Technical Memorandum

To:	Ground-Level Monitoring Committee, Chino Basin Watermaster
From:	Wildermuth Environmental, Inc. (WEI)
Date:	December 13, 2017
Subject:	Task 3 and Task 4 of the Work Plan to Develop a Subsidence Management Plan for the Northwest MZ-1 Area: <i>Development and Evaluation of Baseline and Initial Subsidence-Management Alternatives</i>

Response to GLMC Comments

Figure 1

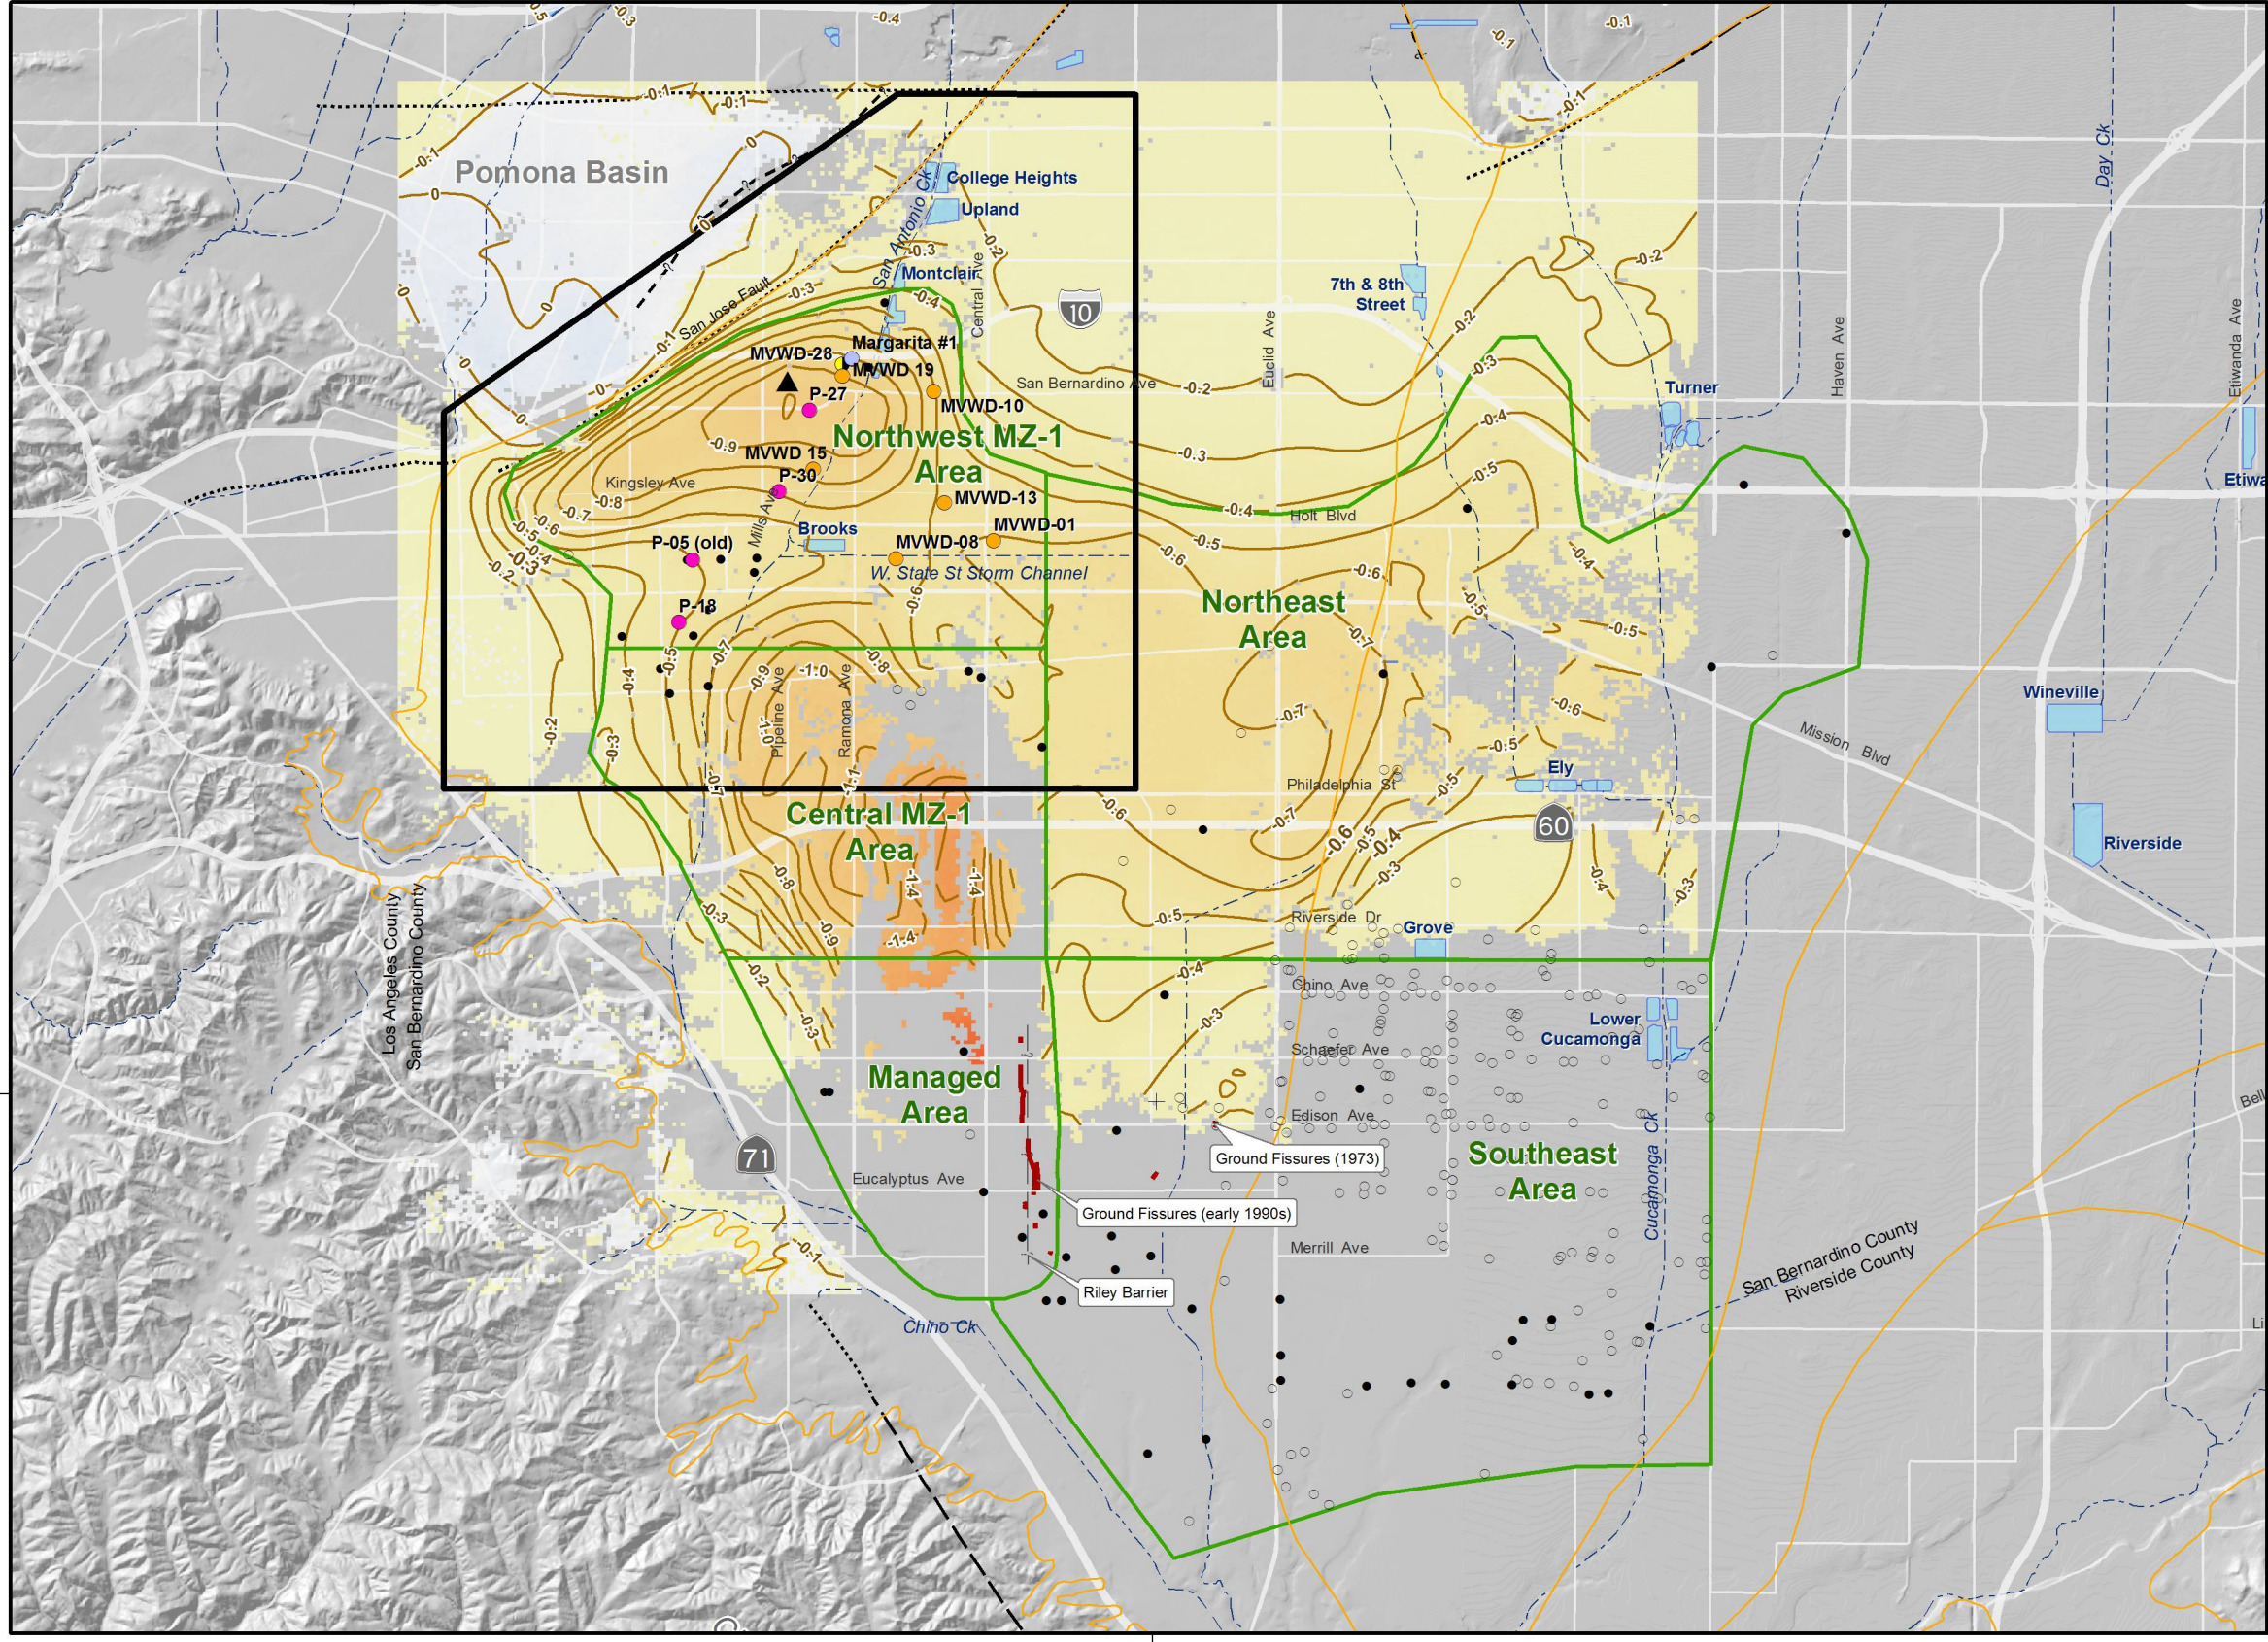
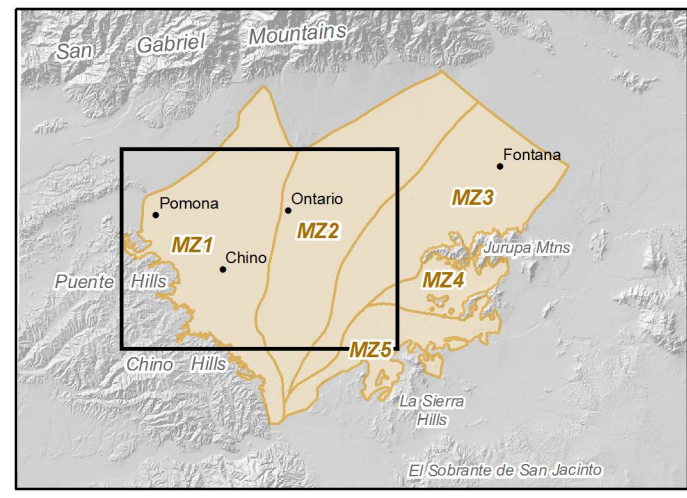
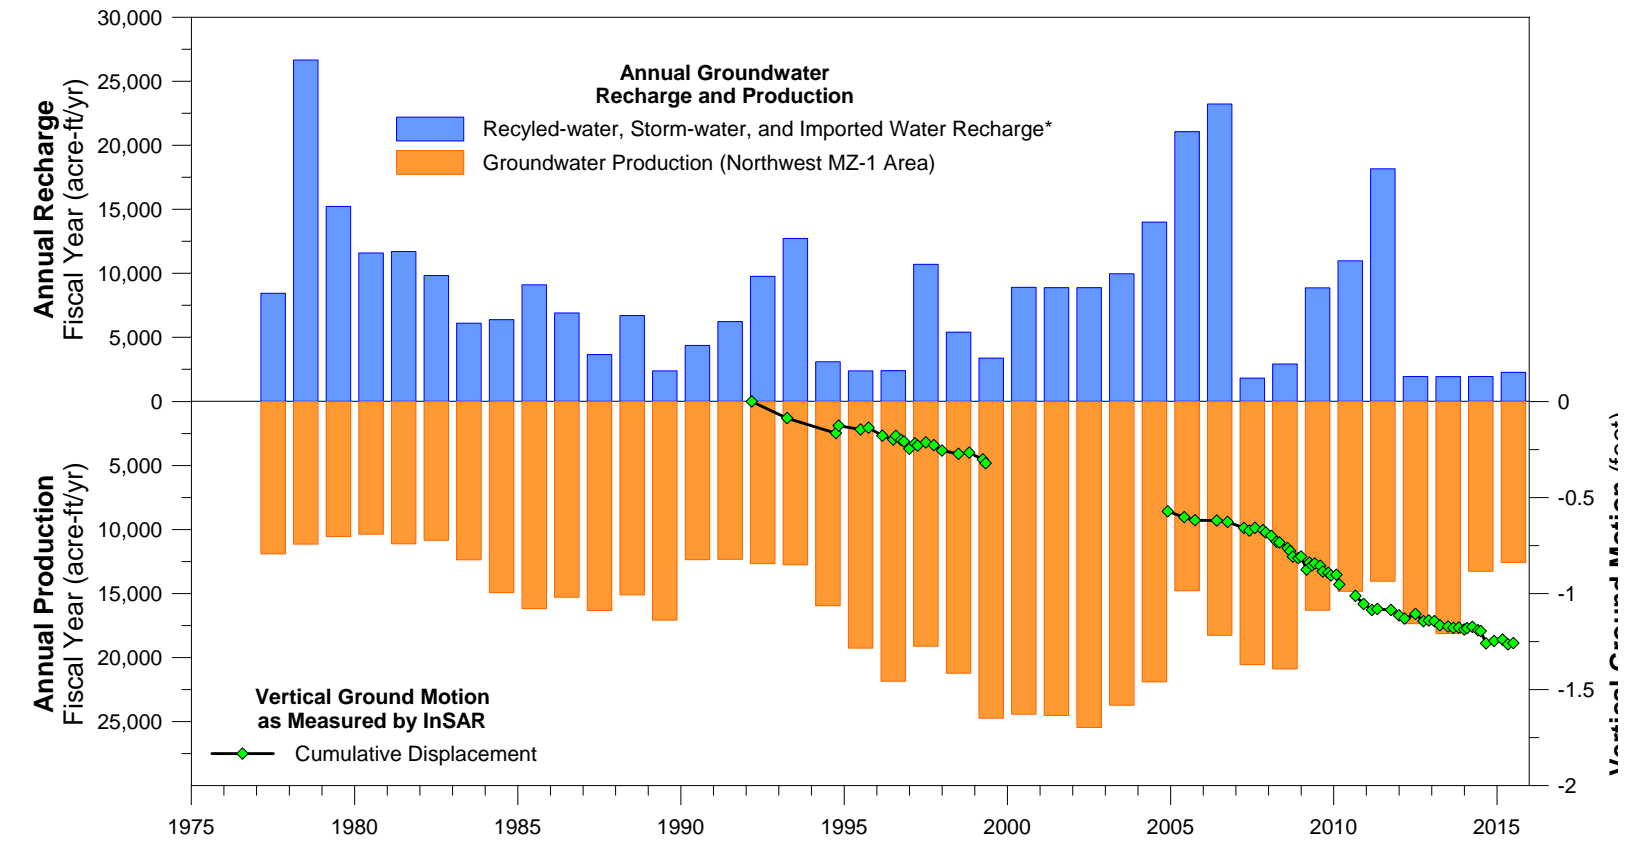
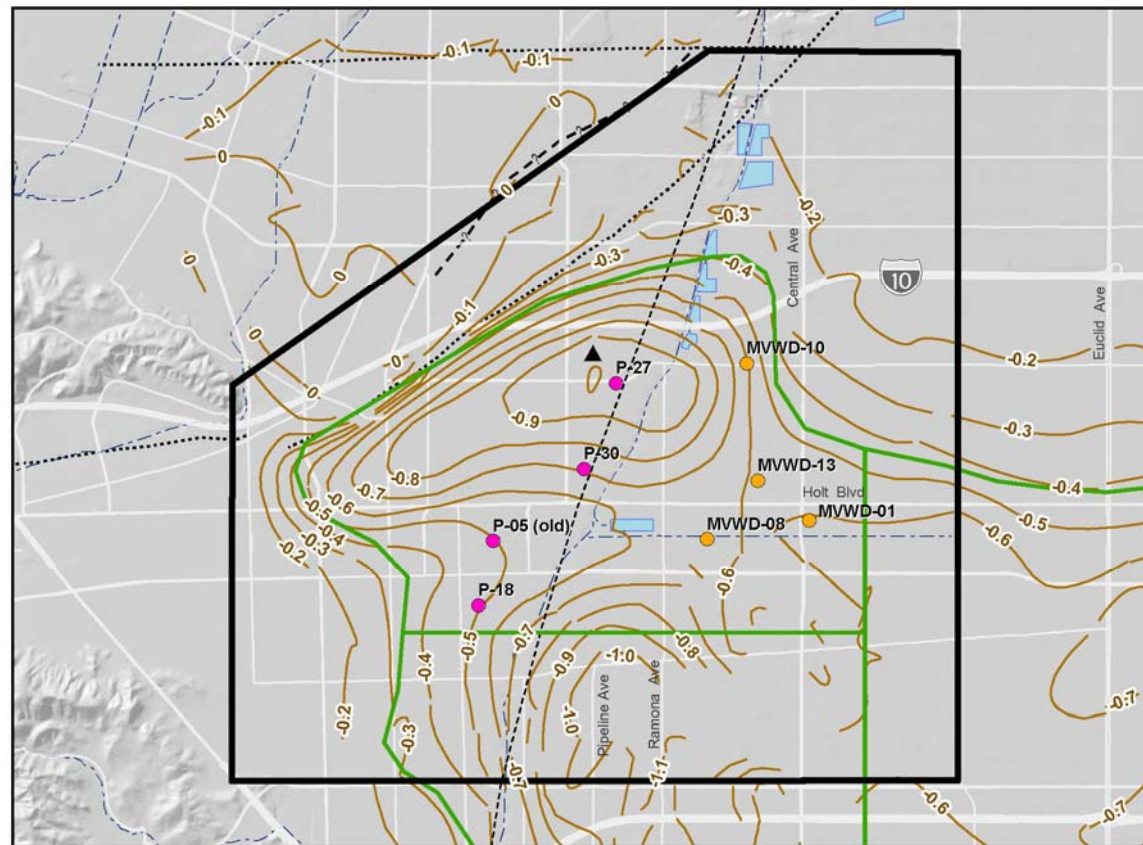
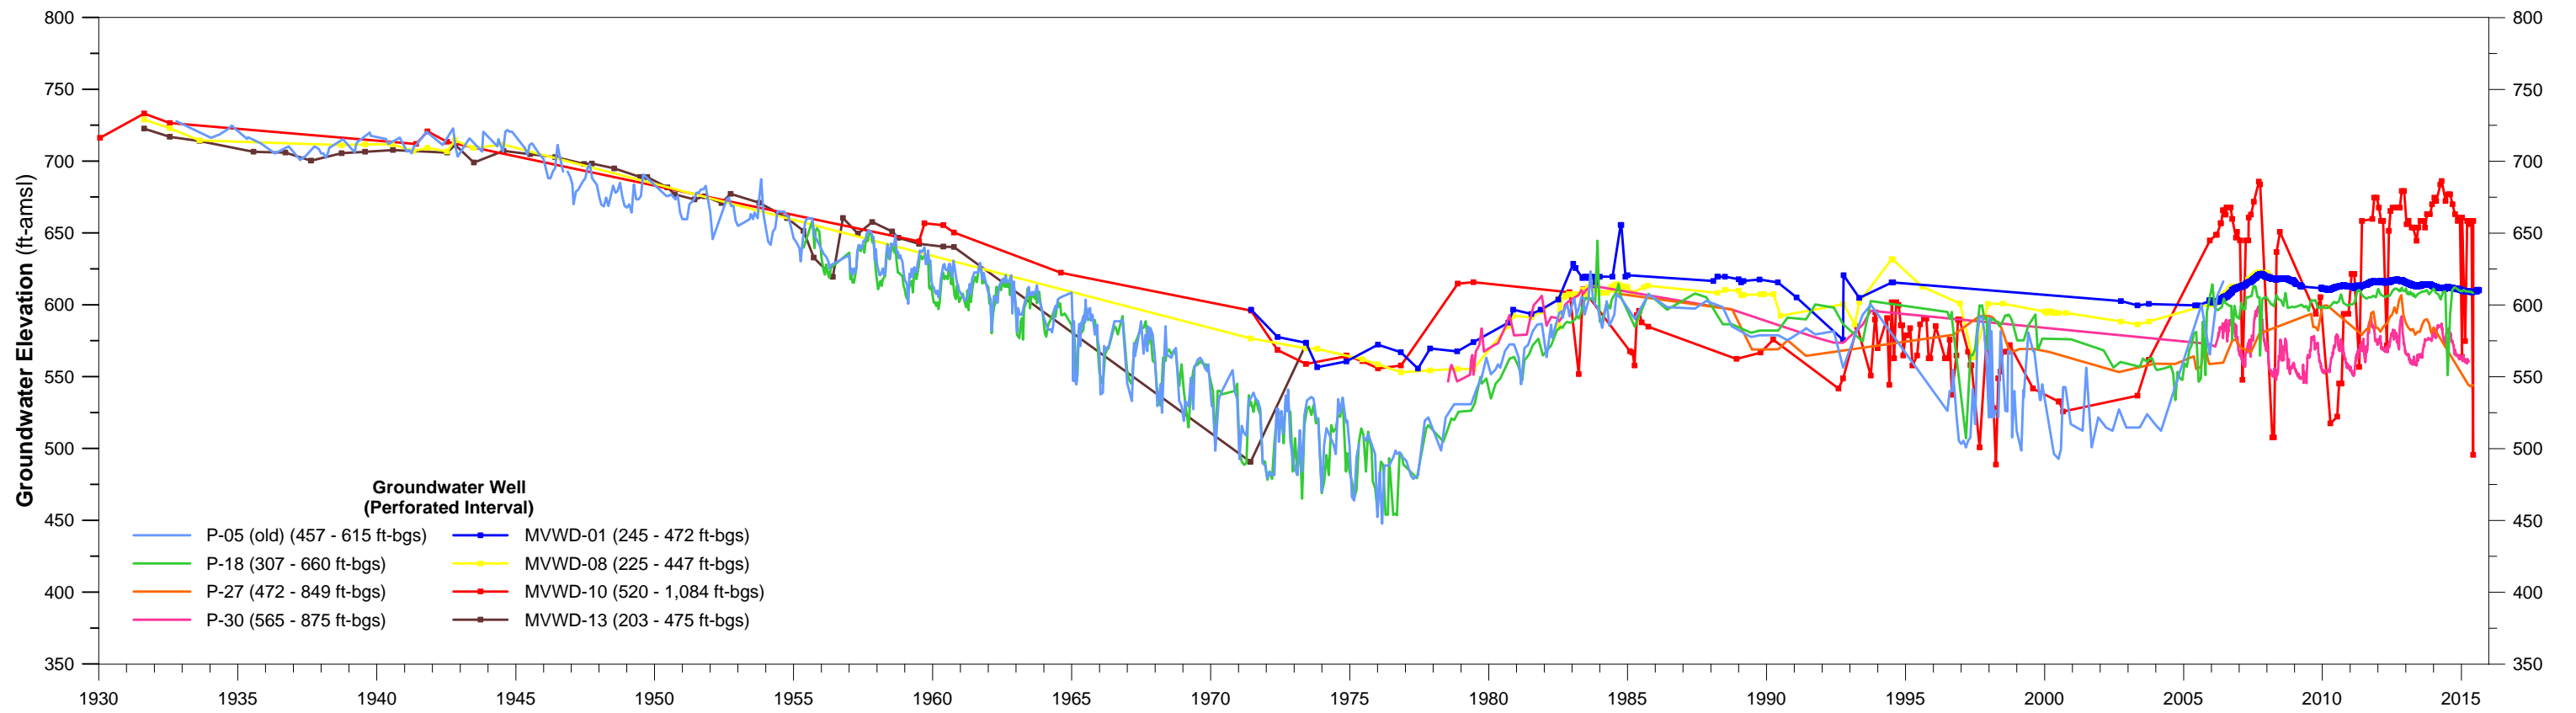
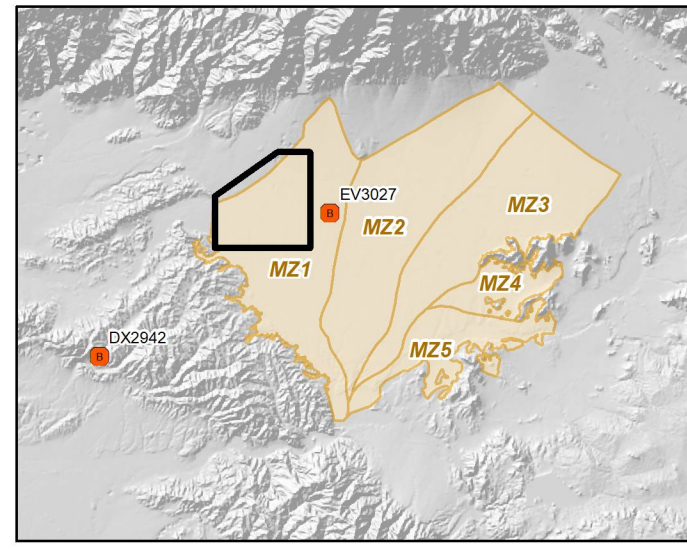
“MVWD-15 “This well is not shown on the either map figure 1 or 2. Do you mean MVWD-13? Also, Well Margarita #1 and MVWD-19 are not shown on either of the maps.

Figure 1 has been updated to include wells: MVWD-15, MVWD-19, and Margarita #1. Thank you.

Figure 4. Generalized hydrogeology of the 1D aquifer-system compaction model and grid based on the MVWD-28 lithologic and resistivity logs. Inset shows the 2-foot cell spacing used throughout the entire model.

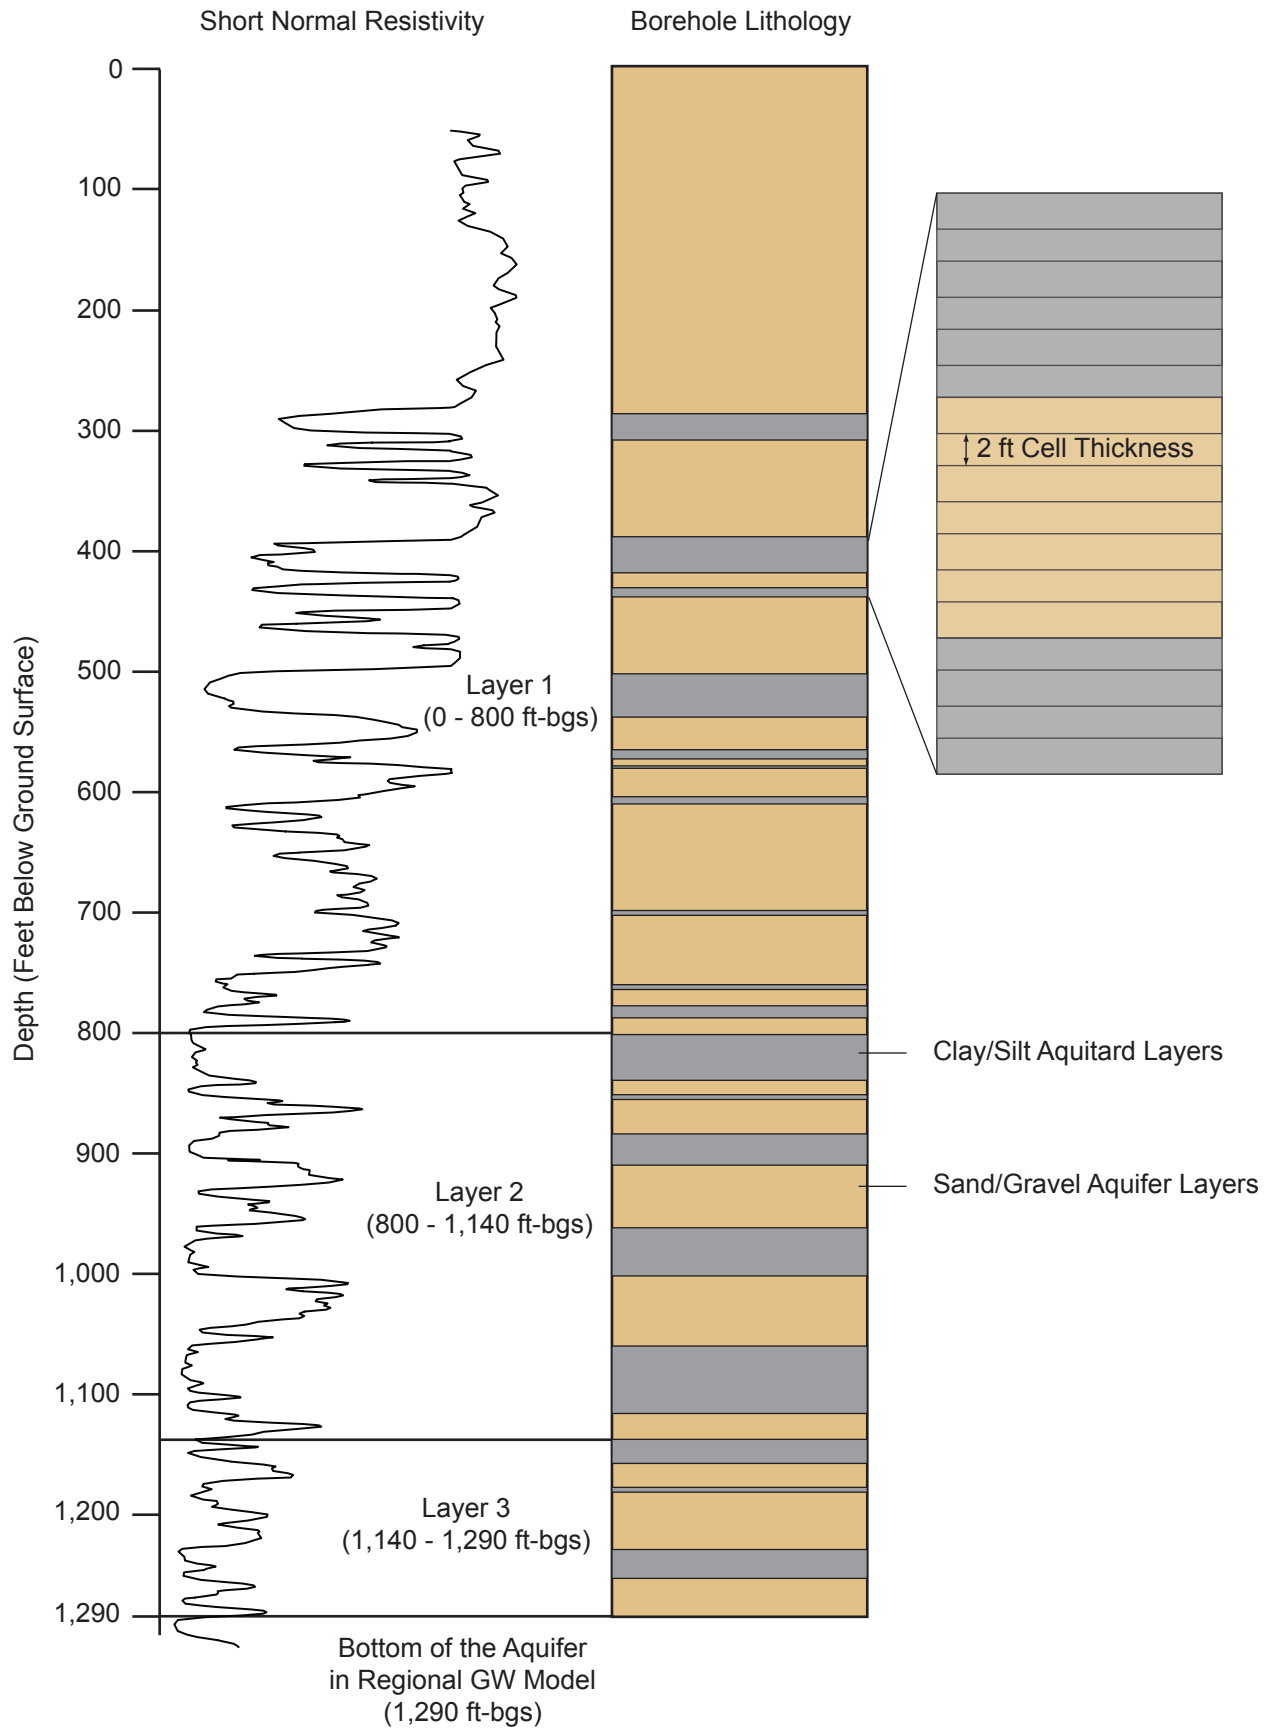
Comment 10, Figure 4:

The 1,290 ft-bgs represents the bottom of the aquifer in the Watermaster's regional MODFLOW groundwater model. A note to this effect has been added to Figure 4.
